Narrabri Gas Project (SSD 6456)
Response to Independent Planning Commission Questions

Summary of Comments on Microsoft Word - Letter to IPC Response to Questions - Narrabri Gas Project.docx

This is my (Mr Tony Pickard) third group of submissions to the NGP IPC process.
Please see the first and supplementary as they are both referred to in these two responses.

This Annotated document by Mr Tony Pickard, is by way of an objection to the NGP and the way the Department Planning Industry and Environment is conducting itself in regards to answering the IPC questions.

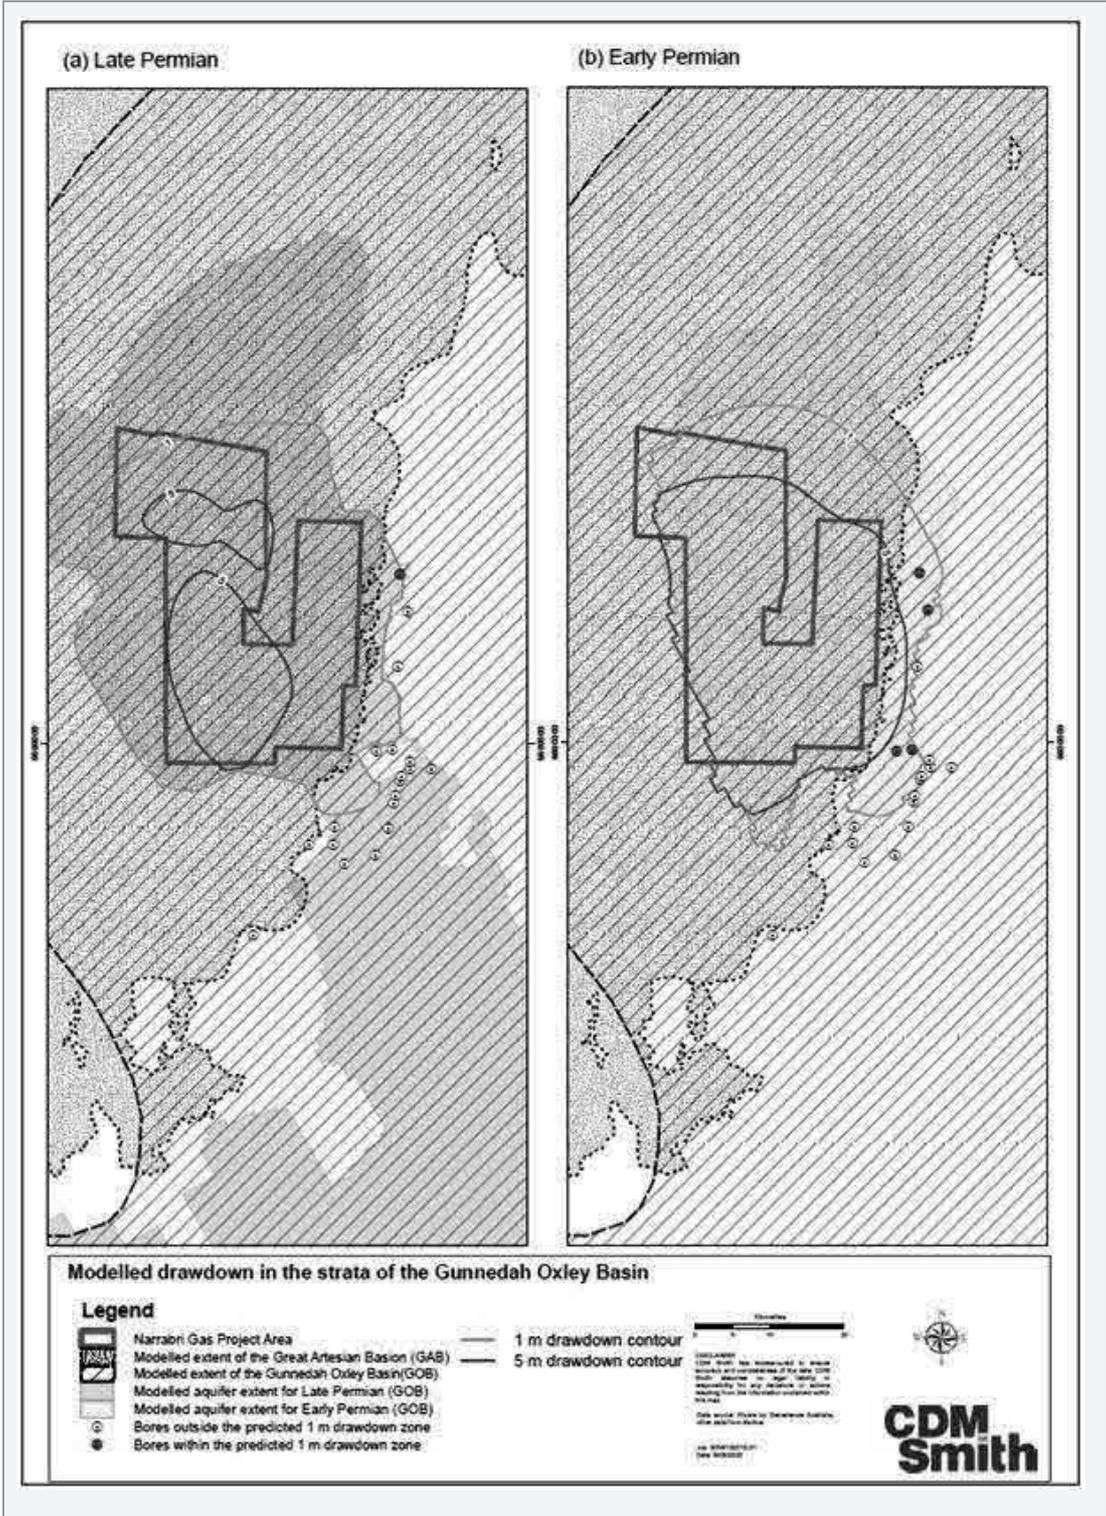
Number: 1 Author: Tony Subject: Sticky Note Date: 19/08/2020 4:21:10 PM

The potential risk of impact to these bores greater than the minimal impact criteria of two metres drawdown is considered negligible. Even if it is assumed that these bores extract water from the same coal seams targeted by the Project (i.e. Early Permian formations of the GOB), groundwater modelling shows only four of these bores are located close enough to be potentially affected (see figure below).

The monitoring network would identify any issues many years (likely decades) in advance of any effect and if required make good provisions would be straightforward and effective. This is consistent with the Department's Assessment Report, and advice to the Department from the Water Expert Panel, that the risk to stock and domestic bores is low.
